## LINCOLN CITY/LANCASTER COUNTY PLANNING STAFF REPORT

-----  
for July 23, 2003 PLANNING COMMISSION MEETING

**P.A.S.:** Change of Zone #3414 - from P to O-3  
Use Permit 152 - Pioneer Pointe Plaza

**PROPOSAL:** To allow up to 49,900 square feet of medical, financial and office floor area.

**UTILITY  
PLAN**

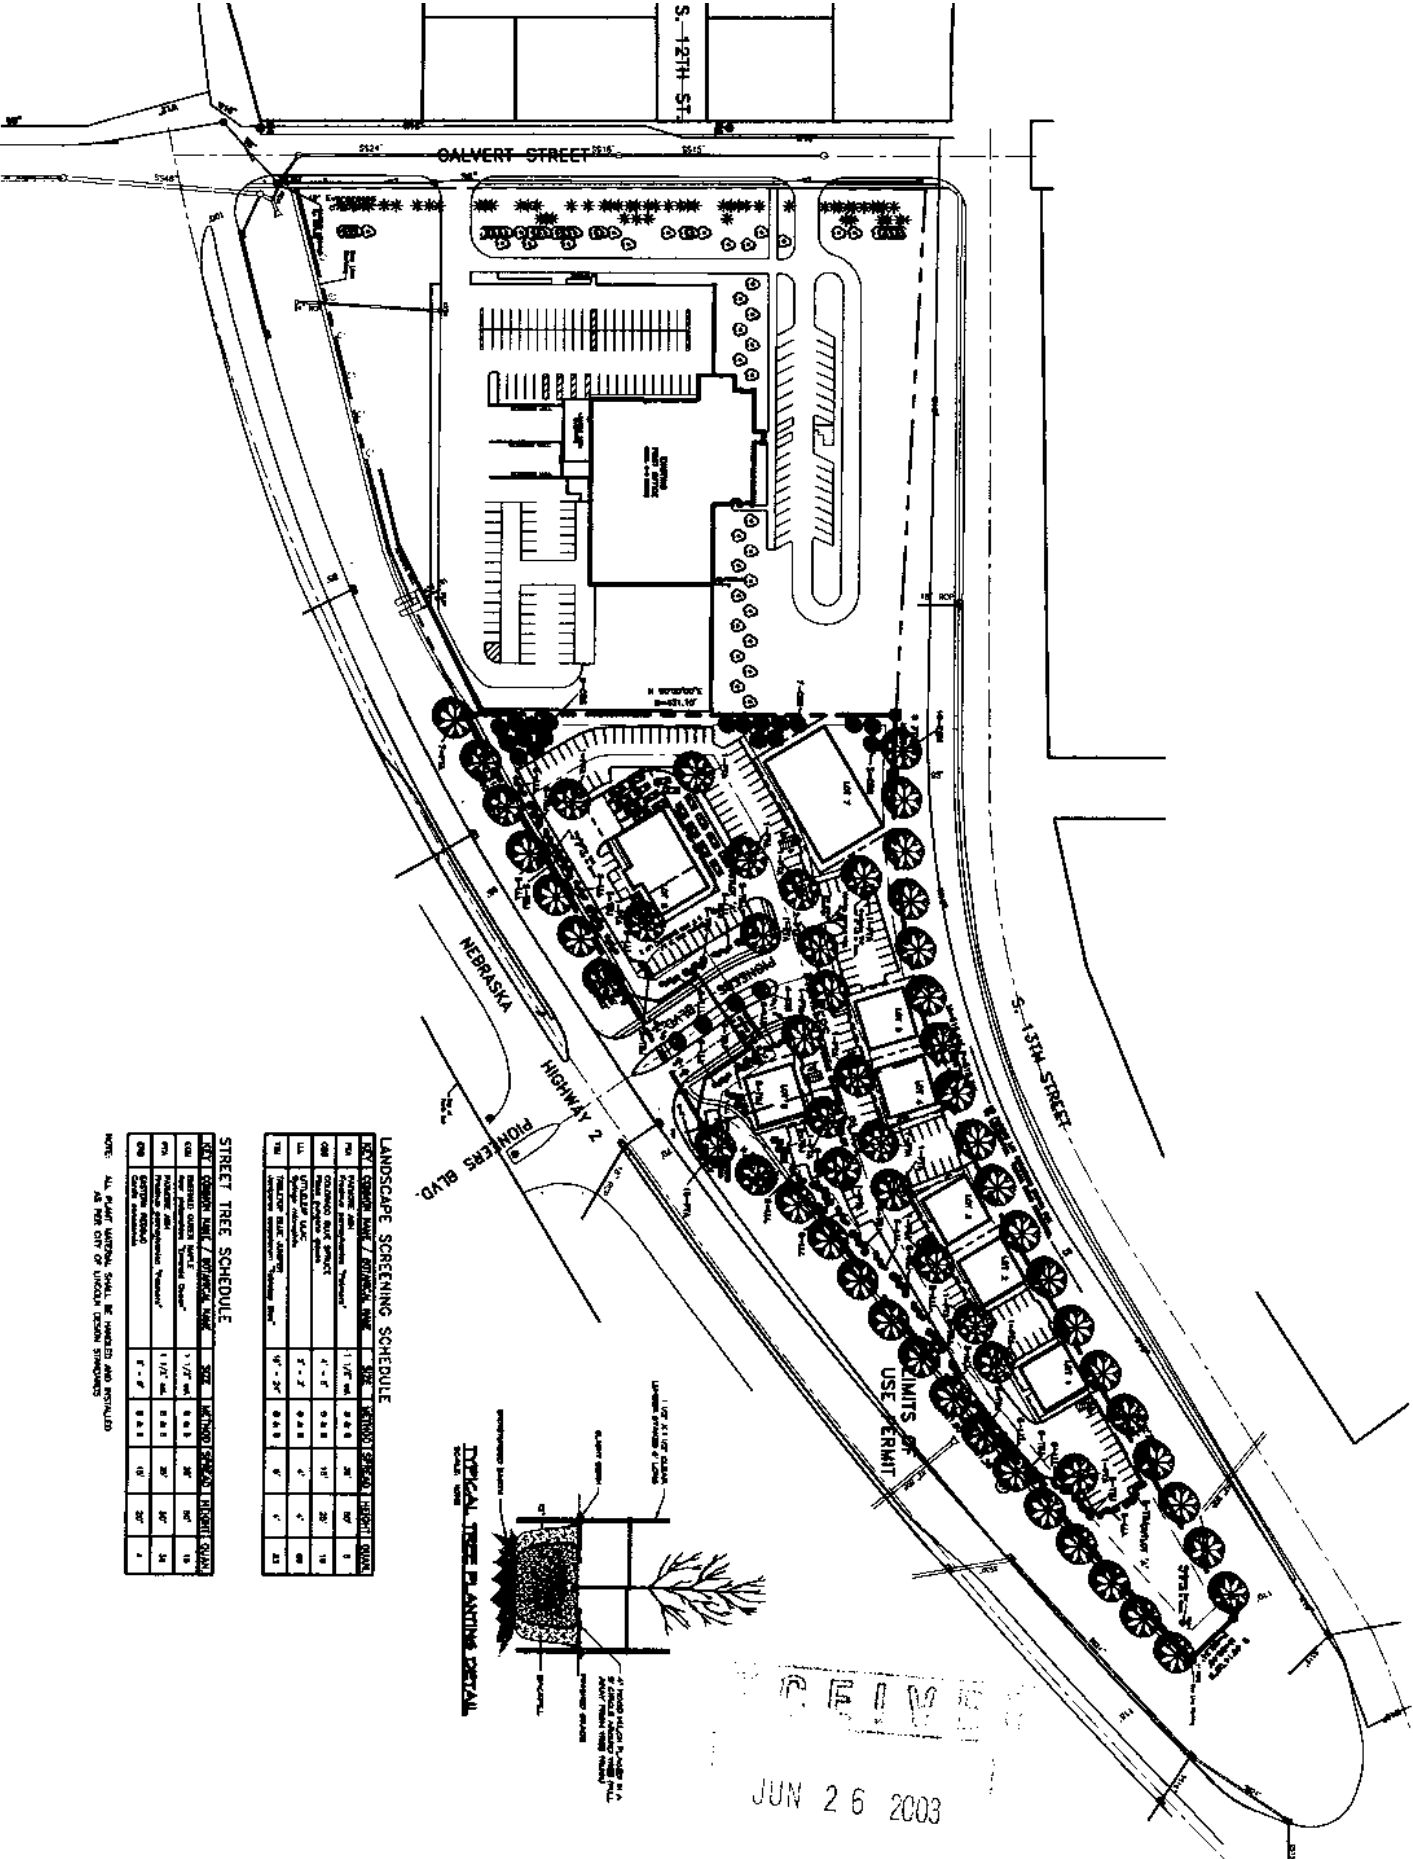
9. Public Works notes that sanitary sewer is acceptable, provided the Nebraska Department of Roads (NDOR) approves the use of right-of-way as shown. Additionally, it was noted that the sanitary sewer runs opposite street grades, contrary to design standards. This is a waiver to Design Standards that was not requested and was not part of the legal notice. As a result, staff is recommending deferral to allow the legal notice to be modified to include it. Public Works supports the waiver provided the sewer depth does not exceed the 15' maximum depth.

**Sanitary** - The sanitary system is satisfactory contingent on the NDOR's review and approval of the use of its right of way for sanitary sewer construction.

A waiver for running sanitary sewer opposite street grade needs to be requested for sewer in Pioneers Place. Public works would support this waiver provided that sewer depth stays under the maximum 15' as per design standards.

LANDSCAPE  
PLAN  
SCALE: 1"=50'

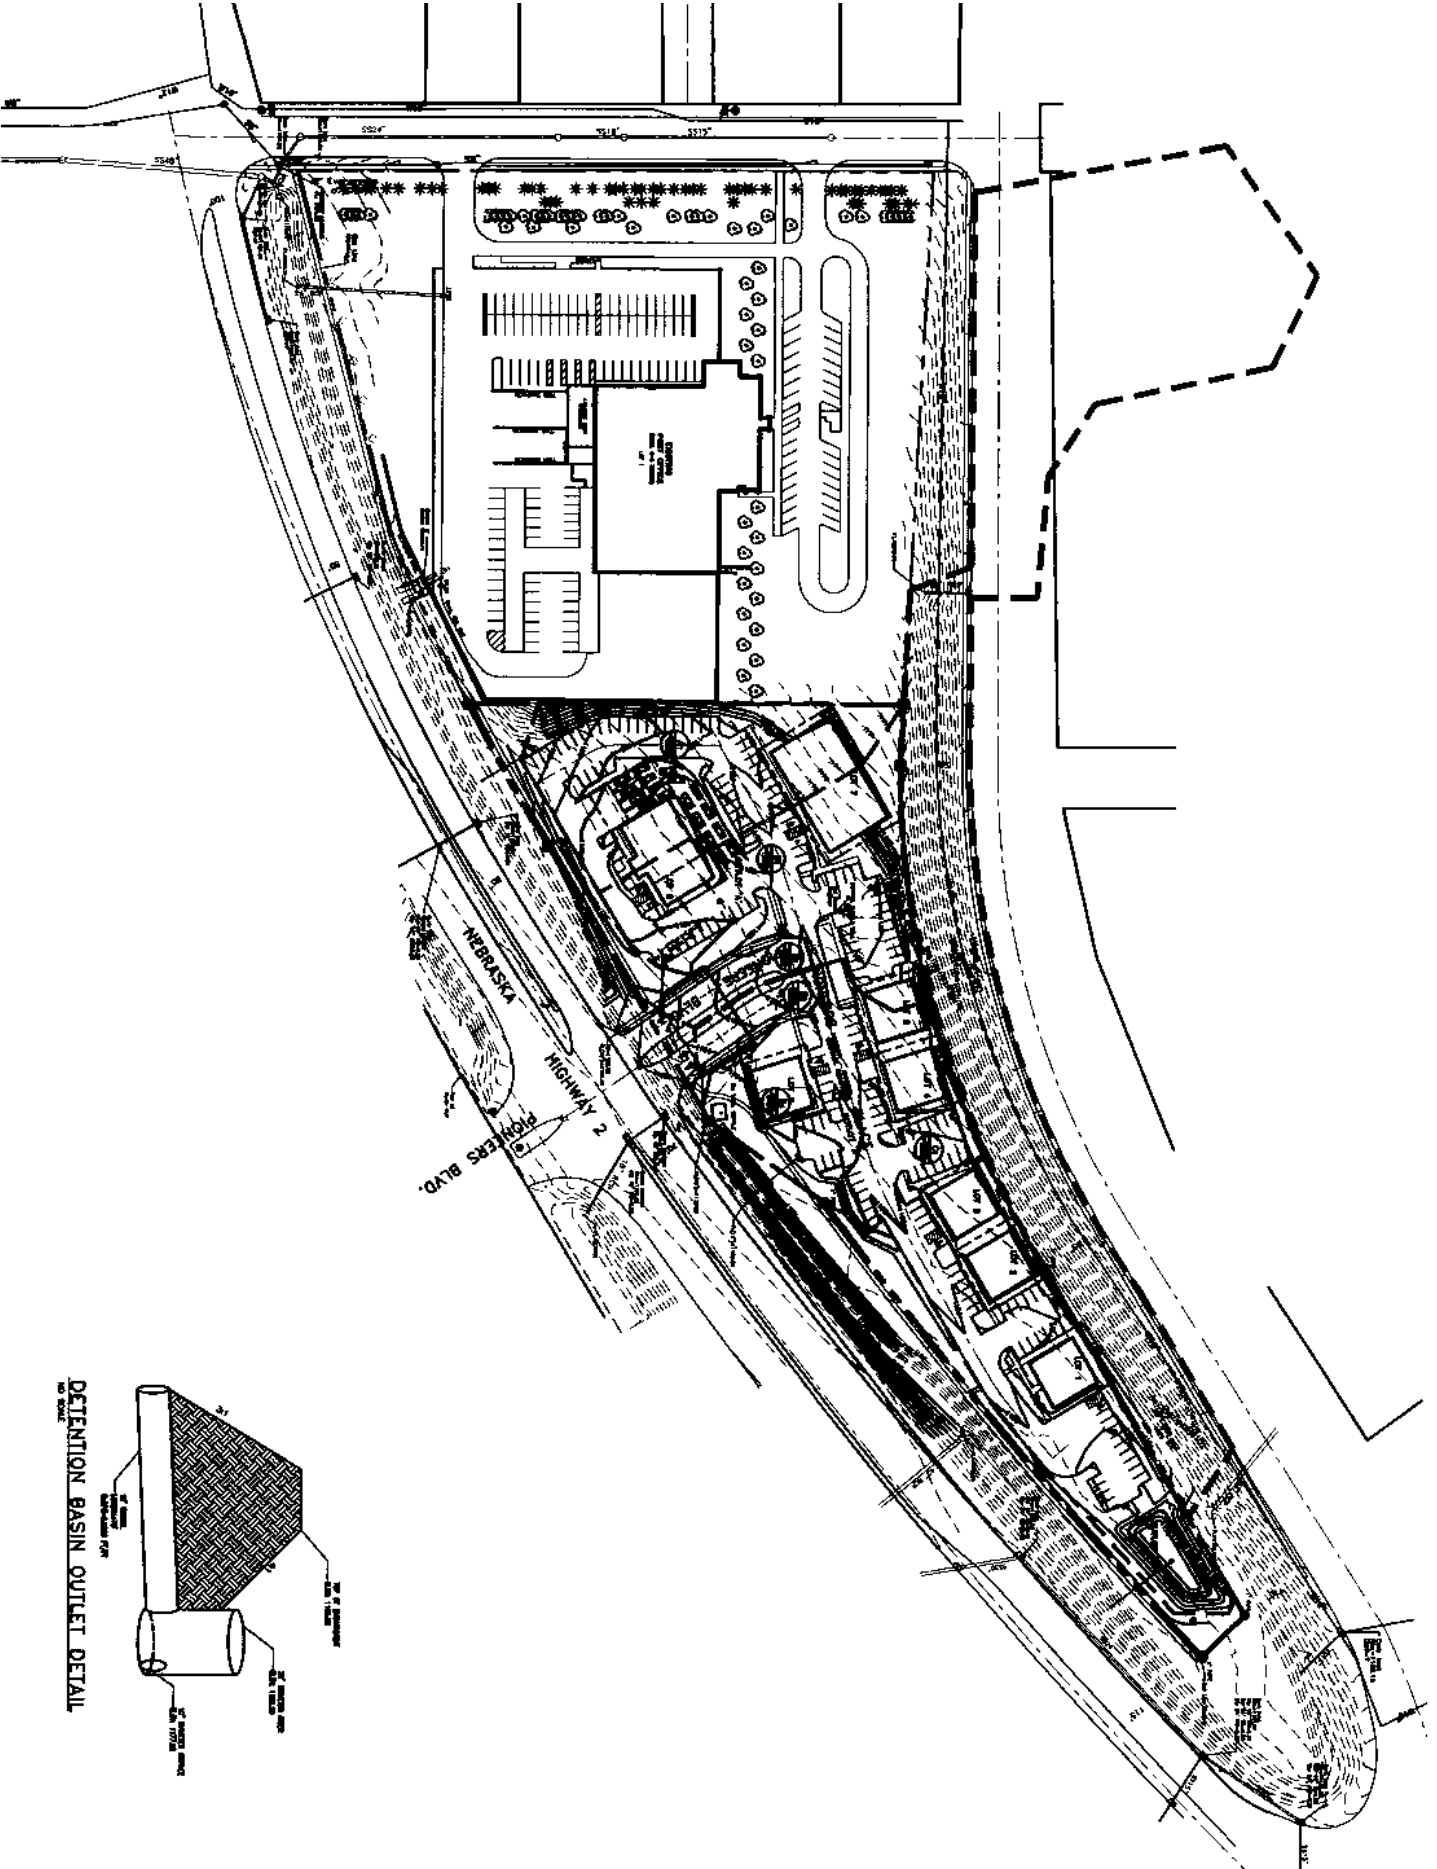
7. A waiver to parking lot screening is requested for the South 13<sup>th</sup> Street frontage - the requirement per Design Standards is a 60% screen from 2'-4' in height. As noted previously, there is a change in grade along the east boundary of the site that varies from between 12' to 16'. This earthen berm will effectively screen any parking lot located adjacent to it, and additional low screening is not necessary provided additional trees are planted along 13<sup>th</sup> Street and in the parking lots. The landscape plan shows the required screening for the remaining sides of the parking lots.

8. The required landscaping for each individual lot is not shown on the landscape plan. This is acceptable provided a note is added to the plan that states the landscape plans for individual lots will be reviewed at the time of building permits.

13. The landscape plan shows two sign envelopes for 8' high signs, 32 square feet in area. Only one sign envelope of this size for office park identification is allowed in the O-3 district. The sign envelope on Lot 8 must be removed as it exceeds what is allowed by the district; the other sign envelope is designated as an identification sign for the development and is allowed, but the location of the envelope must be clearly delineated.

1. Please provide a graded platform for a 10' trail with a 20' trail easement.
2. It is recommended that the trail/trail easement parallel the property line on private property as much as possible.
3. Please use Kentucky Coffeetree as street tree along Highway 2.
4. Emerald Queen Maple struggles during establishment period. Please consider using Autumn Blaze Maple as an alternative.

- 1.1.6 A revised landscape plan showing:
  - 1.1.6.1 Kentucky Coffeetree as the street tree along Highway 2, and that substitutes Autumn Blaze Maple for Emerald Queen Maple.

- 1.1.6.2 Additional trees at the drive entrance to the development, at the south end of Outlot A, and along the east boundary and in the parking lots.

- 1.1.6.3 The sign envelope for the 32 square foot, 8' high sign on Lot 8 deleted, and the remaining center identification sign envelope clearly identified.

- 1.1.7 A note that states "LANDSCAPE PLANS FOR INDIVIDUAL LOTS WILL BE SUBMITTED AND REVIEWED AT THE TIME OF BUILDING PERMITS IN COMPLIANCE WITH THE REQUIREMENTS OF THE CITY DESIGN STANDARDS."

**GRADING  
PLAN**  
SCALE: 1"=50'  
PROJECT: PIONEERS  
DATE: 08/01/01  
BY: J. CARSTENSEN

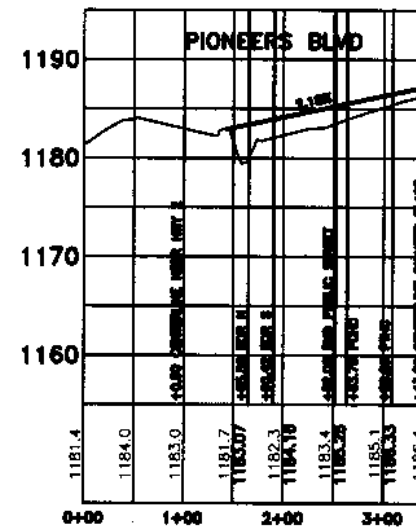
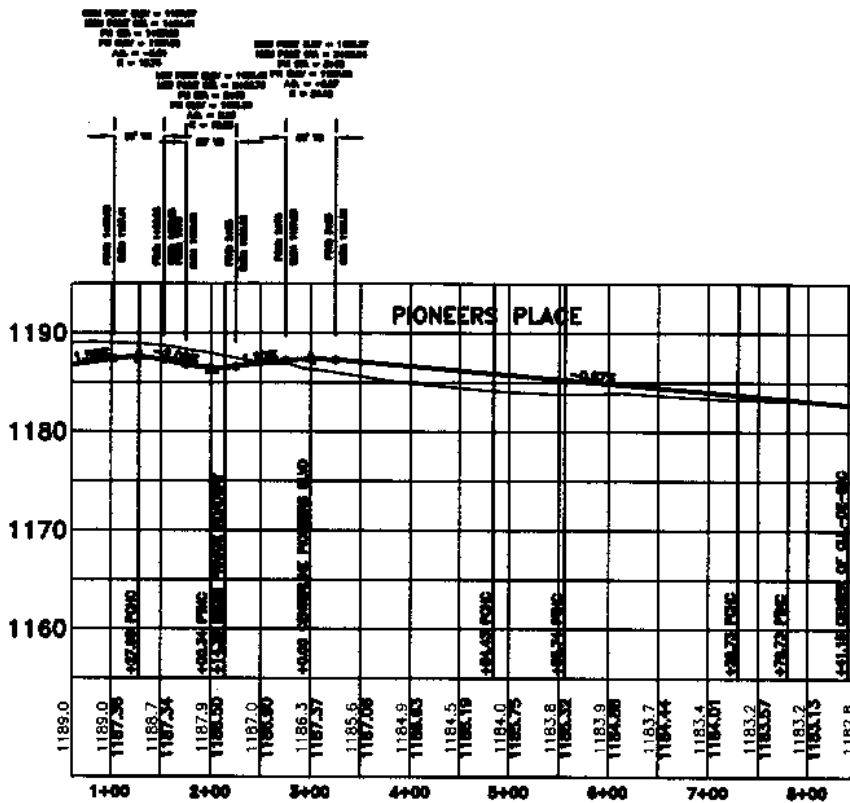
10. The grading and drainage must be revised per Public Works' review. Additionally, NDOR must also approve the grading and drainage plan due to proposed grading within the right-of-way.

**Grading/Drainage** - Grading is shown outside of the property line inside the NDOR right of way. State approval will have to be obtained in order to conduct grading activities in the right of way.

The proposed detention cell is located directly in front of an outlet for an existing 42" storm sewer. The proximity of the 42" outlet to the bank for the cell velocities for the 42" outlet should be calculated and energy dissipation and/or bank stabilization measures will be required if the velocities prove to be erosive.

Although the detention calculations show that the proposed storm water discharge into the state right of way is less than or equal to the existing flow, a permit to discharge water into state right of way will still need to be obtained from the NDOR.

The letter accompanying the application stated a requested waiver for street cross section, specifically eliminating the roadway crown. The grading plan shows a crowned section the entire length of the roadway. If this is the case the waiver is not needed.

- 1.1.4 A roadway cross-section consistent with the waiver request for staff to review.
- 1.1.5 A revised grading and drainage approved by Public Works and Utilities and the Nebraska Department of Roads.
